LOS LUNAS SCHOOLS
RFP 2027-003-HR
2027 E-RATE CATEGORY 2 AND SECURITY CABLING INFRASTRUCTURE SERVICES
AMENDMENT NO. 2
DATE: NOVEMBER 17, 2026

2027 E-RATE CATEGORY 2 AND SECURITY CABLING INFRASTRUCTURE SERVICES
FOR
LOS LUNAS SCHOOL DISTRICT
RFP NO. 2027-003-HR
RFP Amendment No. 2
November 17, 2026

The above referenced RFP #2027-003-HR has been amended as follows:

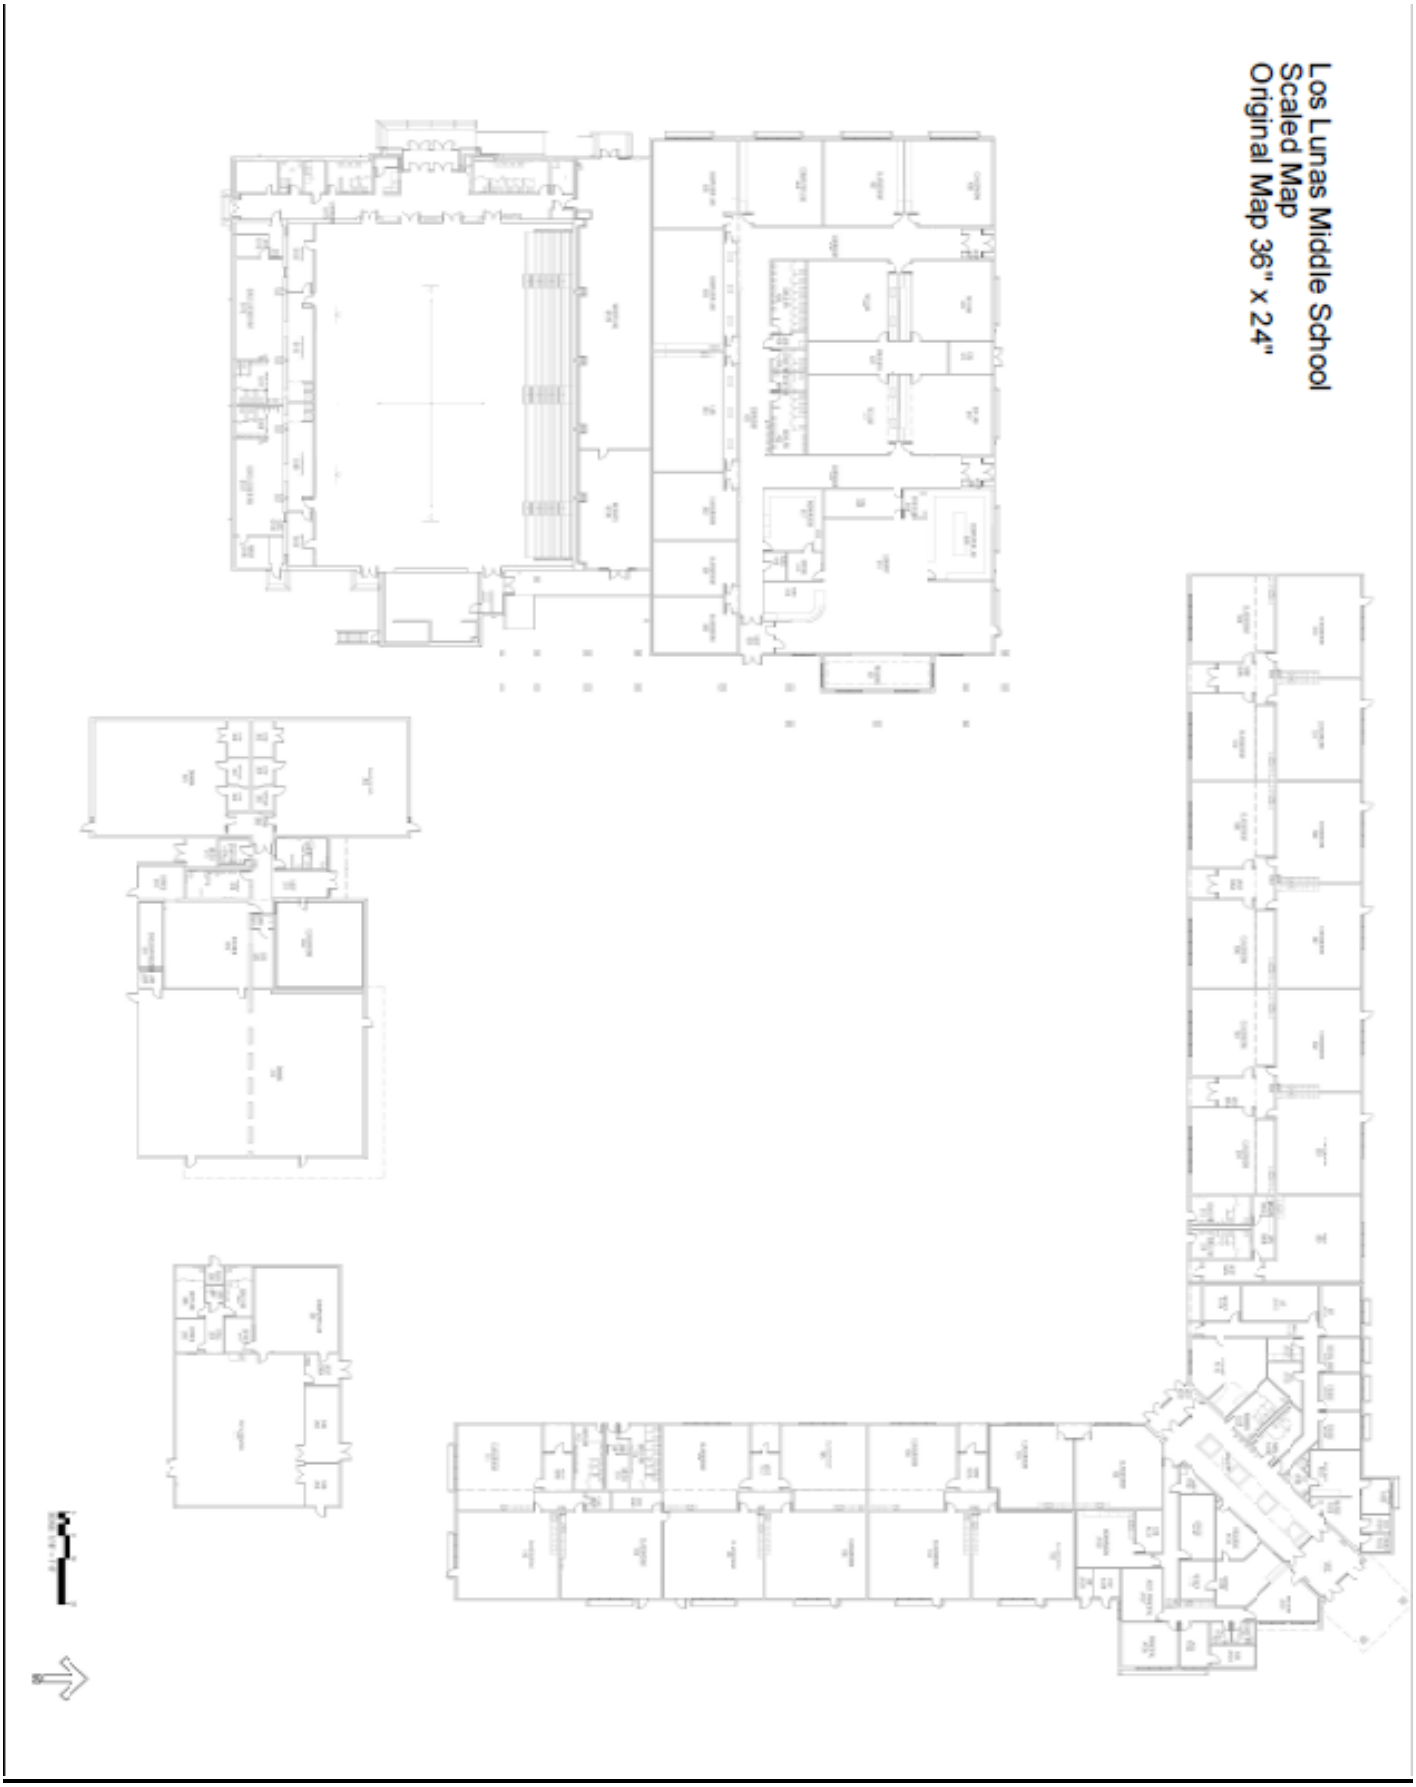
- There are eight (8) power poles in the lab, with four (4) drops in each to be re-cabled, plus additional drops per the map.
- Map Error: The eight (8) power poles in Lab 404 were left off the Data Network Map. All eight (8) power poles and their drops are included in this scope of work.

REVISED-SPECIAL SYSTEMS MAP

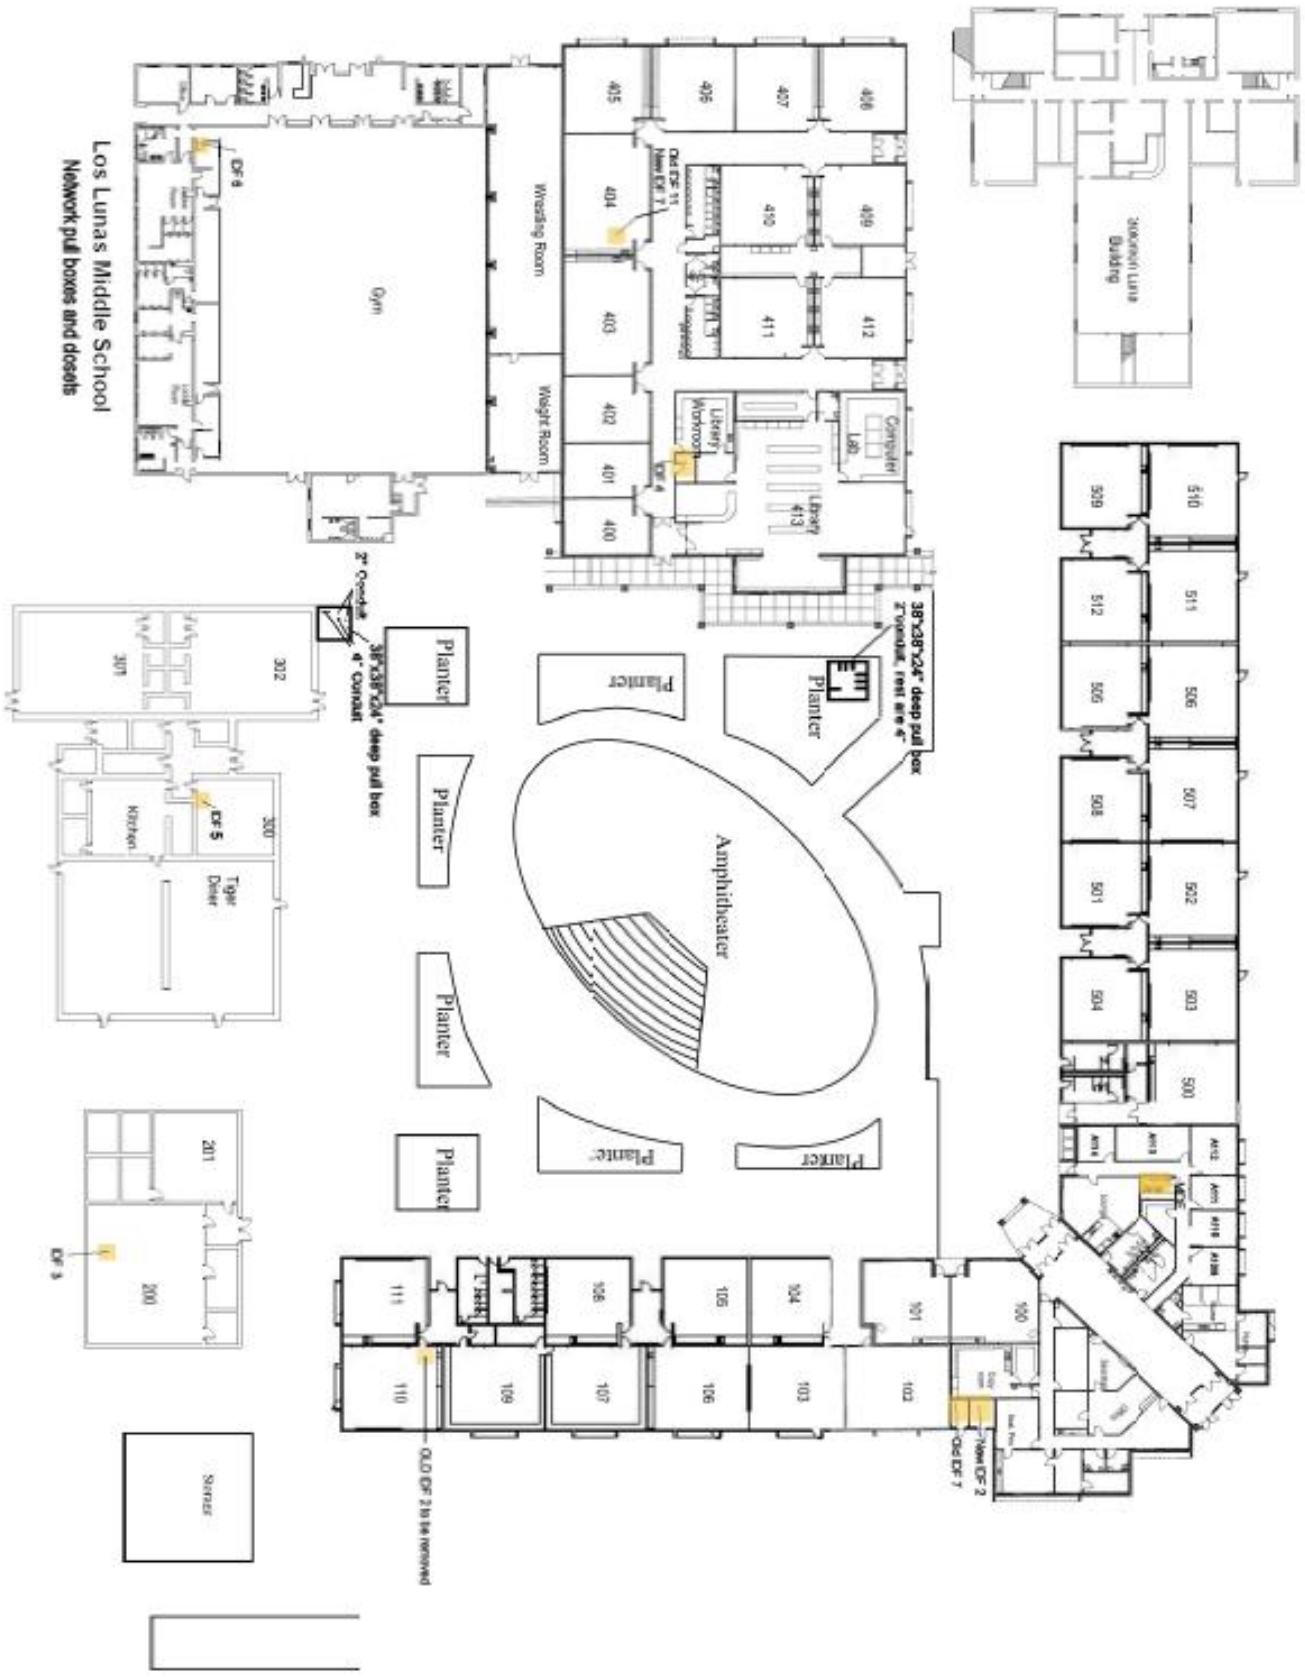
- Provide and install a USB-C Thunderbolt extension (Thunderbolt over Ethernet) from the teaching station to the IFP network drop location such as the Icron Arbutus 63301 or equivalent. Provide two (2) 3-meter USB-C Thunderbolt patch cords per classroom: one (1) at the IFP and one (1) at the teaching station. Refer to Cat 2 map for locations. ~~Pro AV/IT Integrator Series™ HDBaseT 4K60Hz HDMI + USB-C Wall Plate Extender Kit with USB 2.0, Audio & PoC up to 230ft or equivalent.~~
